ENGINEER'S CERTIFICATION FOR MESA DEL SOL, COMMUNITY CENTER, PARKING BLOCK 'F' & 'O'
I, James D. Hughes, NMPE # 11674, of the firm URS Corporation, hereby certify that this project has been paved and graded and will drain in substantial compliance with and in accordance with the design intent of the approved plan dated 11/12/2008 except as noted below. The record information edited onto the original design document has been obtained by me. I further certify that I have personally visited the project site on 7/17/2008 and have determined by visual inspection that original planned elevations are representative of actual site conditions and are true and correct to the best of my knowledge and belief. This certification is submitted for city files as requested in the permit letter dated 12/8/2008.

MESA DEL SOL
COMMUNITY CENTER
PARKING BLOCK F & O
ALBUQUERQUE, NEW MEXICO

DATE:
SEPTEMBER 9, 2008
SHEET TITLE:
PAVING, GRADING,
AND DRAINAGE PLAN
SHEET NUMBER:
SHEET 1 OF 418

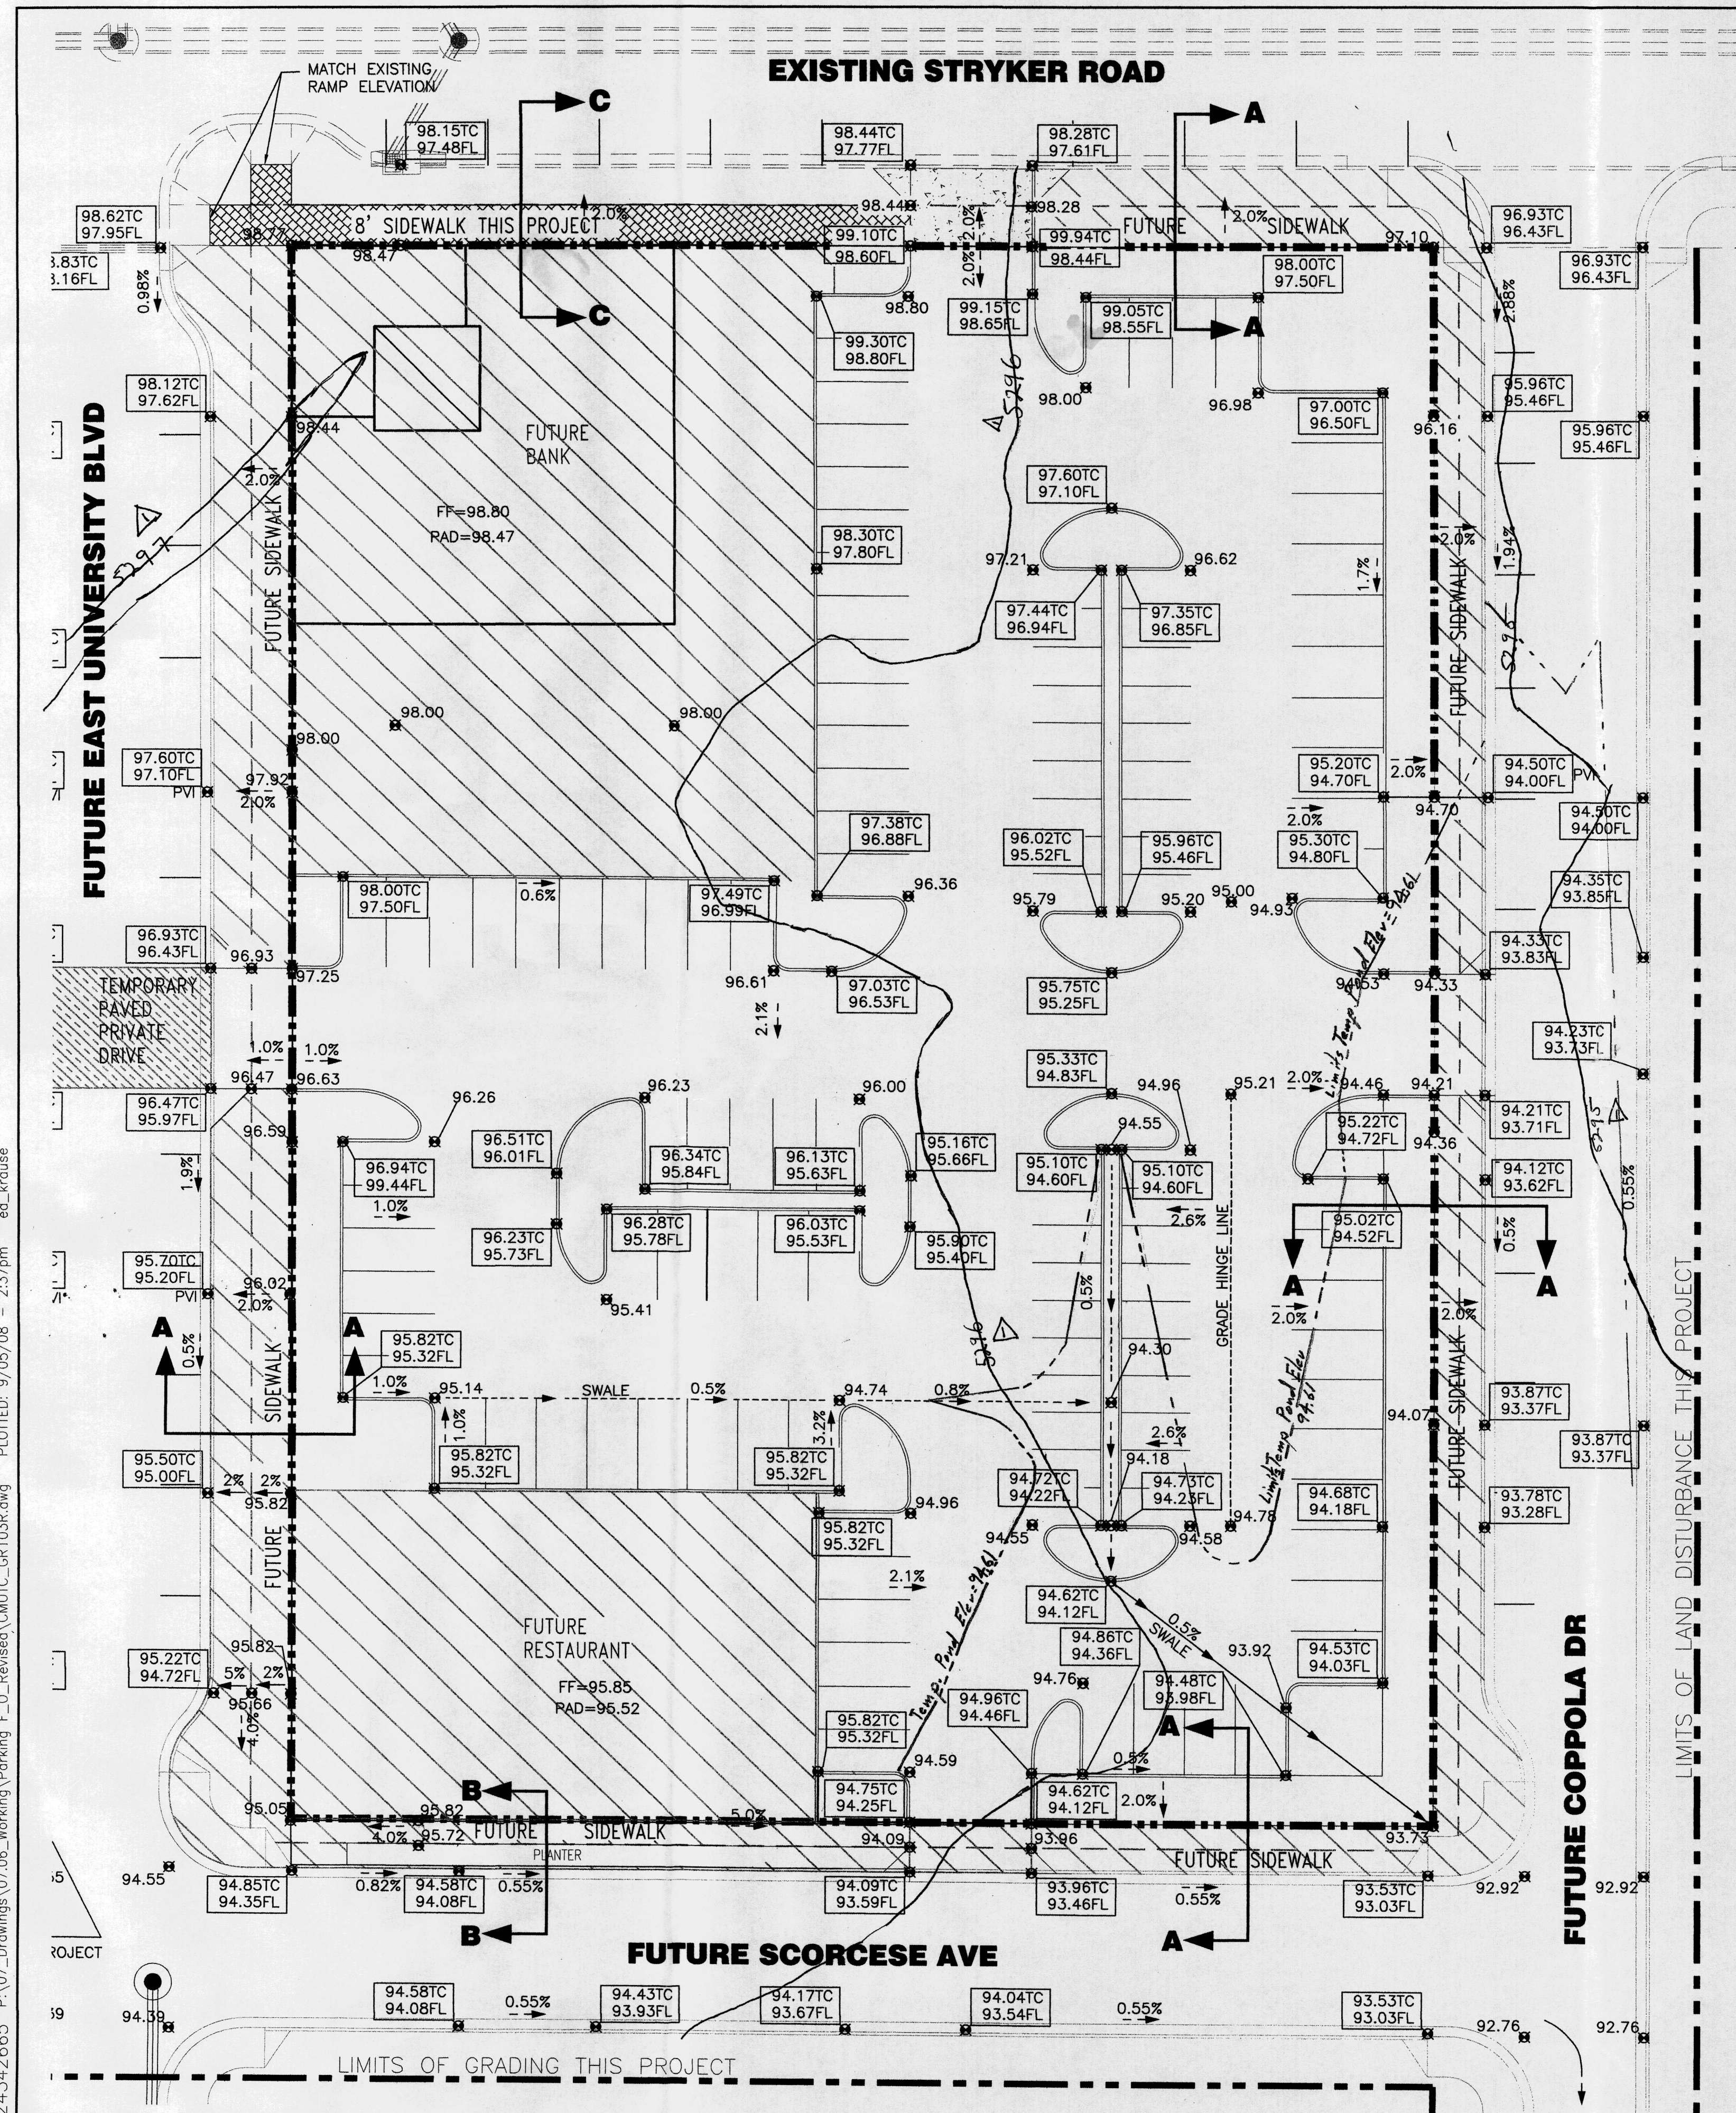
Noteworthy deviations from the approved plan include:
1) The offsite retention pond replaced with retention ponding in the offsite future roadway on the same parcel of land with the same private ownership as the pond was originally located on. Only private water, no public water, drains to the ponding site. As-built volume calculations by conic section equation are as follows:
The record information presented herein is not necessarily complete and is intended only to verify substantial compliance of the paving, grading, and drainage aspects of this project. Those relying on this record document are advised to obtain independent verification of its accuracy before using it for any other purpose.

Handwritten Note:
Temporary Pond Relocated to Future Roadway
Grading This Project

Elev. (Ft)	Area (SF)	Volume (Ac-Ft)
5287.00	0	0
5293.00	33170	1.52
5294.00	43865	2.40
5294.61	3.10	3.10
5295.00	54560	3.62

DATE:
SEPTEMBER 9, 2008
SHEET TITLE:
PAVING, GRADING,
AND DRAINAGE PLAN
SHEET NUMBER:
SHEET 4 OF 4

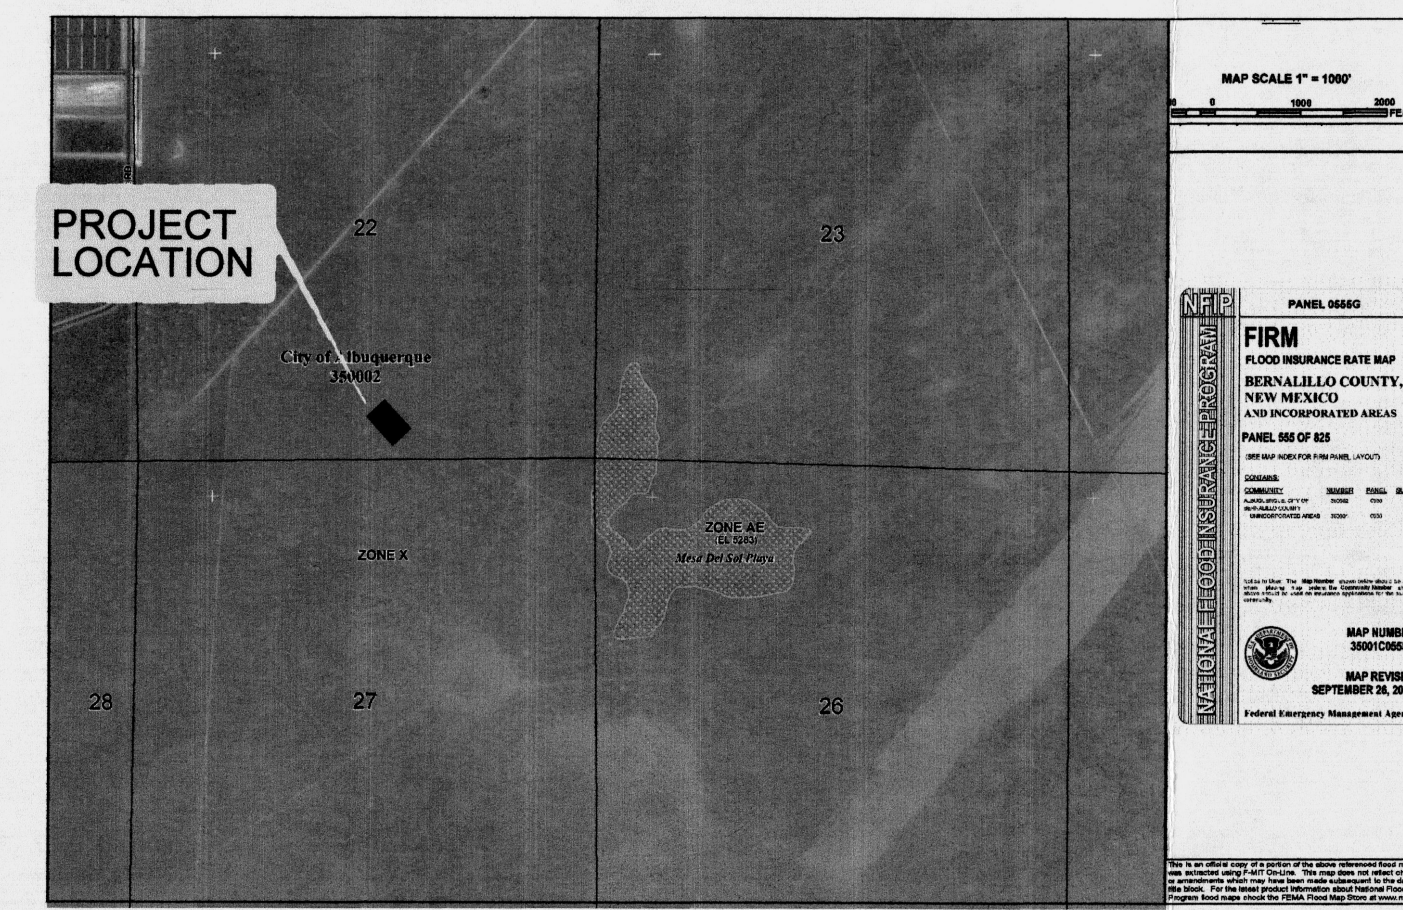
1) The offsite retention pond replaced with retention ponding in the offsite future roadway on the same parcel of land with the same private ownership as the pond was originally located on. Only private water, no public water, drains to the ponding site. As-built volume calculations by conic section equation are as follows:
The record information presented hereon is not necessarily complete and is intended only to verify substantial compliance of the paving, grading, and drainage aspects of this project. Those relying on this record document are advised to obtain independent verification of its accuracy before using it for any other purpose.

This sheet void, see sheet
1 of 4 for limits of Temp. Pond.

Elev. (Ft)	Area (SF)	Volume (Ac-Ft)
5287.00	0	0
5293.00	33170	1.52
5294.00	43865	2.40
5294.61		3.10
5295.00	64560	3.62
